UNITED STATES PATENT AND TRADEMARK OFFICE

APPLICATION NO.	FILING DATE	FIRST NAMED INVENTOR	ATTORNEY DOCKET NO.	CONFIRMATION NO.
10/619,669	07/15/2003	Partab Jeswani	DP-307786	7172

Office Action Summary

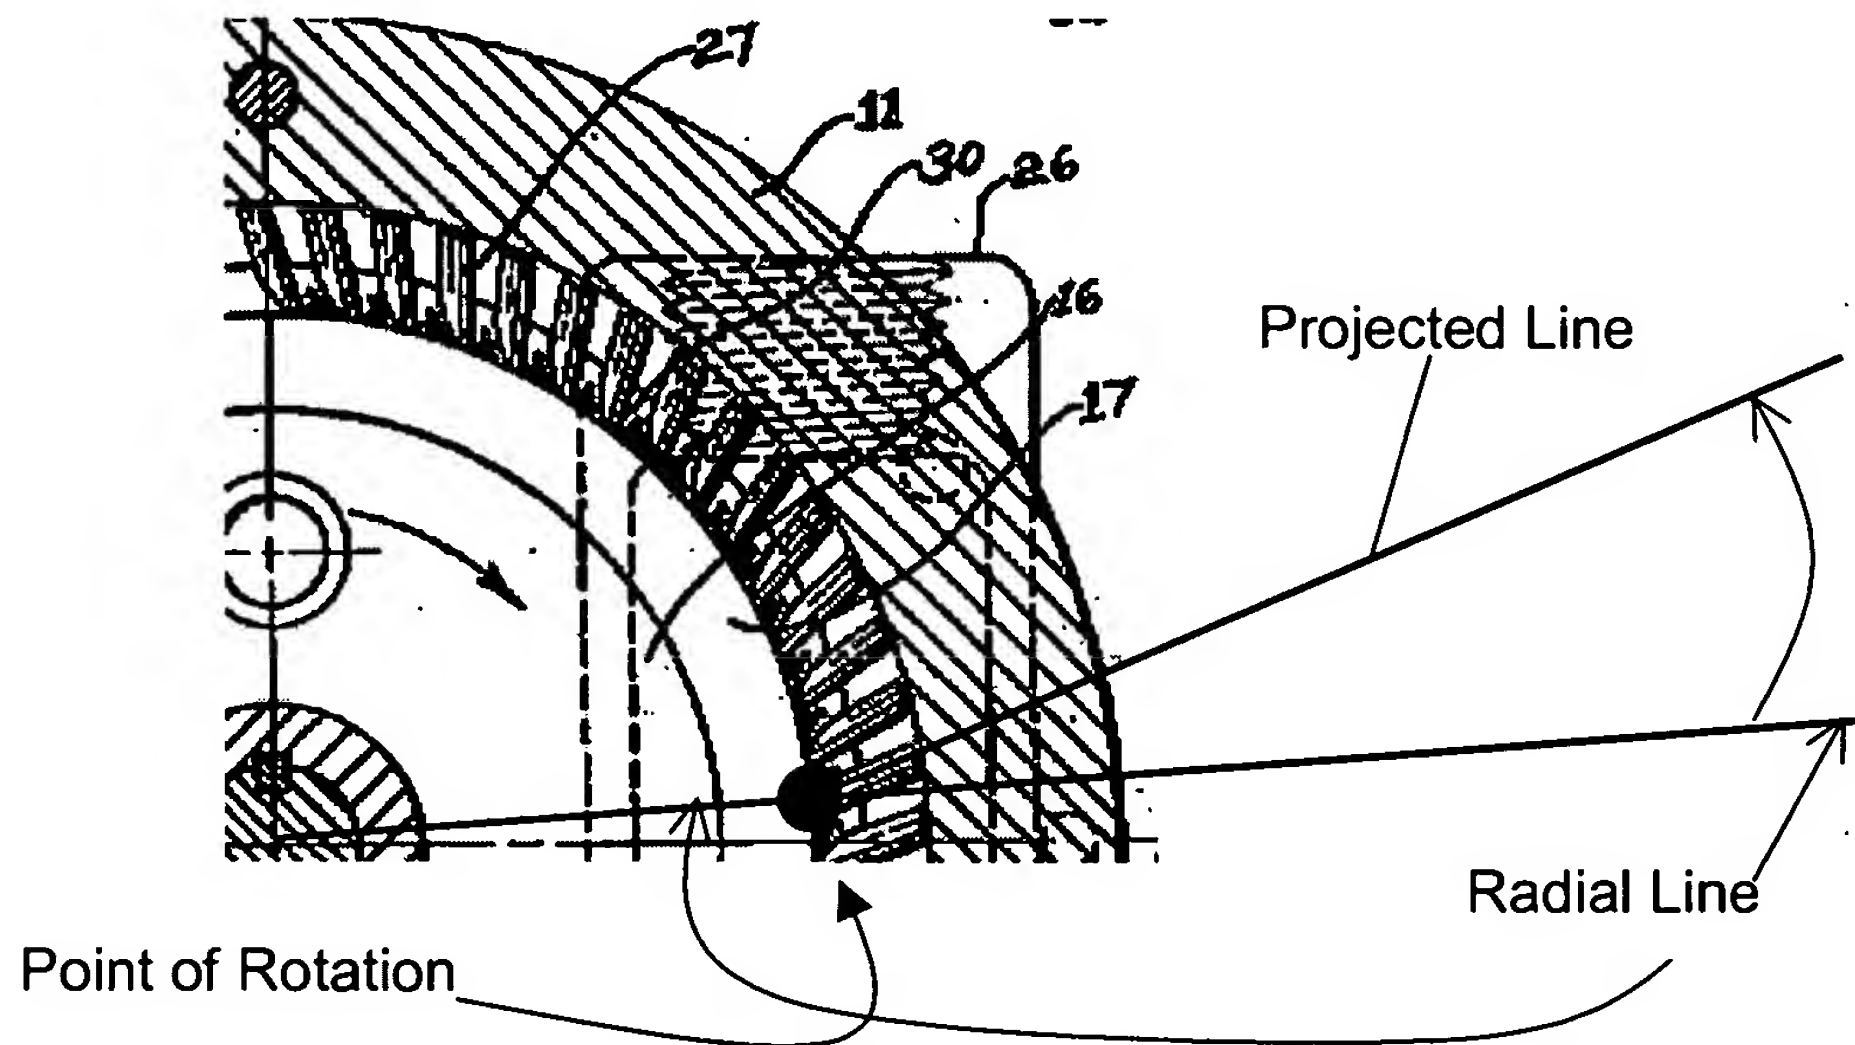
The Brady, Jr. reference (U.S. Patent No. 2,283,844) inherently requires, through the enabling figures, a point of rotation at the hub diameter through which a radial axis extends and each of the blades having a trailing edge being slanted by an angle by a line projecting from the trailing edge through said point. The annotated drawing below illustrates the rotation point and related lines.

The examiner submits that if the Brady, Jr. blades are to be slanted as shown, there is inherently a point of rotation of the hub outer diameter, otherwise, the blades would not be slanted since they would lie in the radial direction.

The blades 27 inherently have a point of rotation at the hub diameter through which a radial axis extends and each of the blades having a trailing edge being slanted by an angle by a line projected from the trailing edge through the point of rotation. The above-stated inherency is supported by the slanted blades shown in Fig. 2, since the blades are not radial.
